BROUGHTON ROAD SUBDIVISION, **STOKLEY'S ADDITION TO**

APPLICATION NUMBER 7 DATE August 6, 2009
APPLICANT Broughton Road Subdivision, Stokley's Addition to
REQUEST Subdivision

DETAIL SITE PLAN

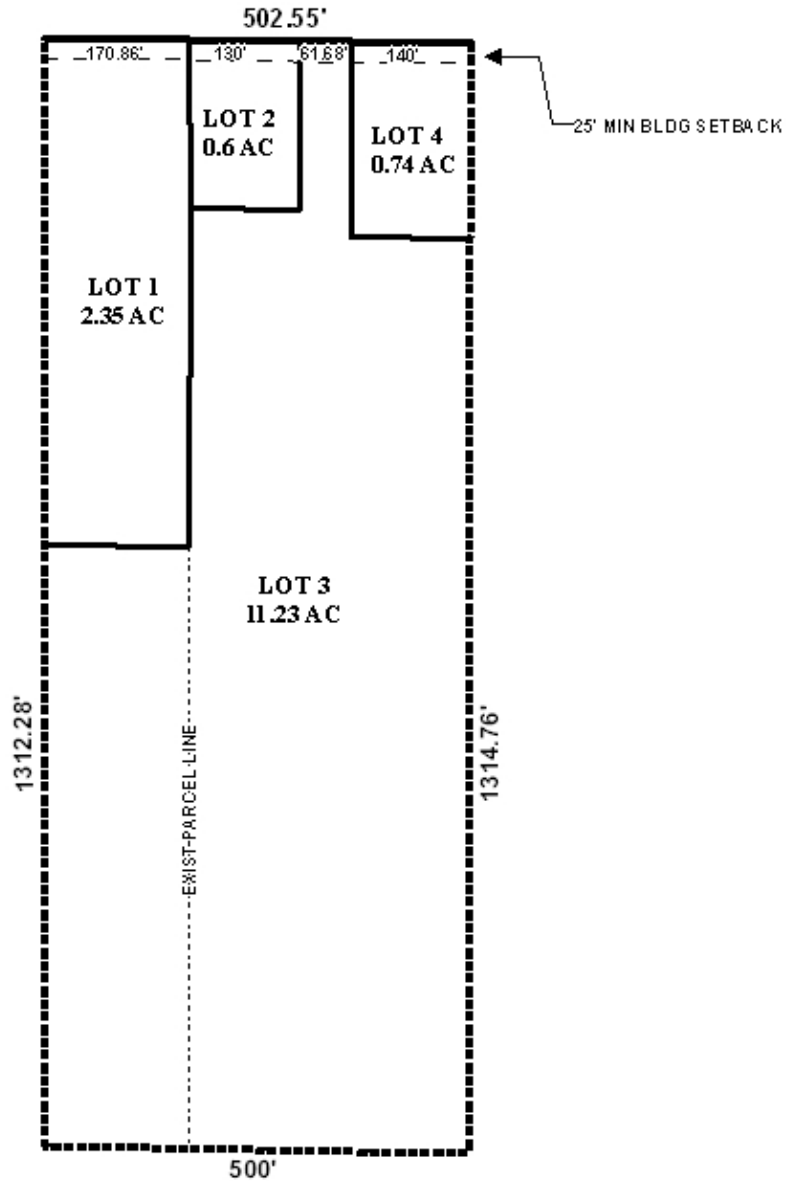
The proposed Lot 1 does not comply with Section V.D.3 of the Subdivision Regulations regarding maximum depth. The maximum depth of the lot allowed by the Subdivision Regulations is 598.01 feet (3.5 times 170.86). The proposed lot is depicted as being 600 feet in depth. It should be noted that the lot is currently 170.86 feet wide and 1312.28 feet deep, thus, the new lot configuration, while still only slightly out of conformity, is still an improvement. Further, this type of lot configuration is not uncommon for the area of the site, and thus, a waiver of Section V.D.3 may be appropriate for this lot.

The proposed Lot 3 is an irregularly shaped lot, which also does not comply with Section V.D.3. However, as with the proposed Lot 1, a review of the parcels in the immediate area of the site reveals that irregularly shaped lots of this type are not uncommon in this area, and thus, Lot 3 could be approved with a waiver of Section V.D.3.

The site has frontage on Broughton Road, a minor street, not provided with curb and gutter. A 50-foot right-of-way is depicted for the street, and Section V.B.14 of the Subdivision

Regulations requires a right-of-way of 60 feet for such streets. As such, dedication sufficient to provide 30-feet from the centerline of Broughton Road should be provided.

The 25-foot minimum building line is depicted, and should be revised to depict 25 feet from any dedication required.

The proposed Lot 1 and Lot 4 both have one existing curb cut to Broughton Road as shown on aerial photographs. Lots 2 and 3 do not have any existing curb cuts, and should be limited to one curb cut each with the size, design, and location of all curb cuts to be approved by Mobile County Engineering.

- 1) Retention of labeling of the lot sizes, in square feet, on the final plat
- 2) Revision of the 25-foot minimum building setback line revised to depict 25 feet from any dedication required;
- 3) Provision of dedication sufficient to provide 30-feet from the centerline of Broughton Road;

- 4) Placement of a note on the final plat limiting Lots 1 and 4 to the existing curb cuts and limiting Lots 2 and 3 to one curb cut each with the size, design, and location of all curb cuts to be approved by Mobile County Engineering;
